**NAESB Wholesale Electric Quadrant  
Ratification Ballot - Due March 21, 2011  
Submit via Email ([naesb@naesb.org](mailto:naesb@naesb.org)) or Fax (713-356-0067)**

Midwest ISO is submitted the attached comments for future consideration on “WEQ 2010 Annual Plan Items 4(a) and 4(b): Review and develop business practice standards to support DR and DSM-EE programs” Recommendation.

### Current Version of Graphic

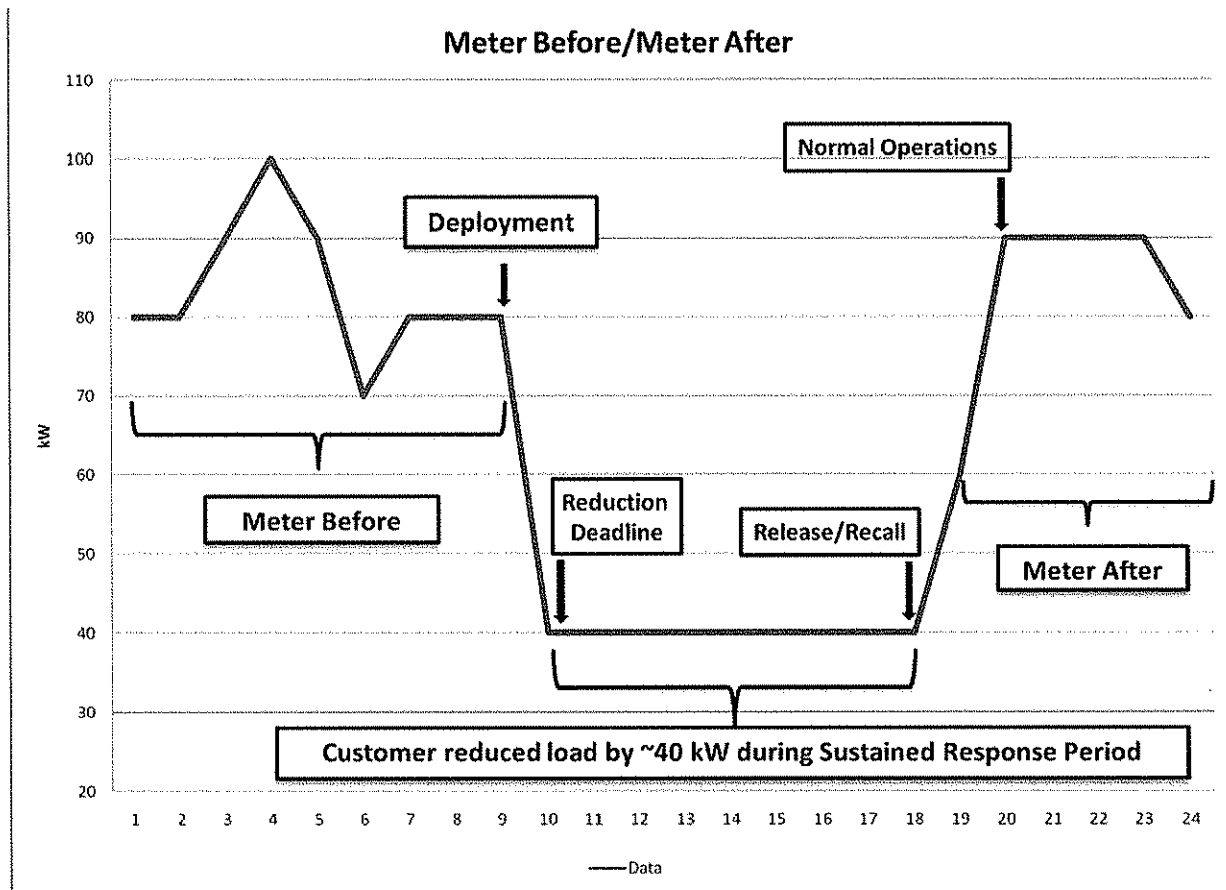
The Meter Before/Meter After diagram has an error in the location of the Meter After bracket. The diagram indicates the Meter After is the period after returning to Normal Operations. However, the textual description on Meter Before/Meter After indicates that comparison is between a period of time prior to deployment (Meter Before) and similar readings during the Sustained Response Period (Meter After). Based on the textual description the diagram should have the Meter After period from Reduction Deadline to Release/Recall. Due to the correction being typographical in nature, NAESB should consider addressing this inconsistency via a minor correction if the proposed standards are ratified.

# Corrected Version of Graphic
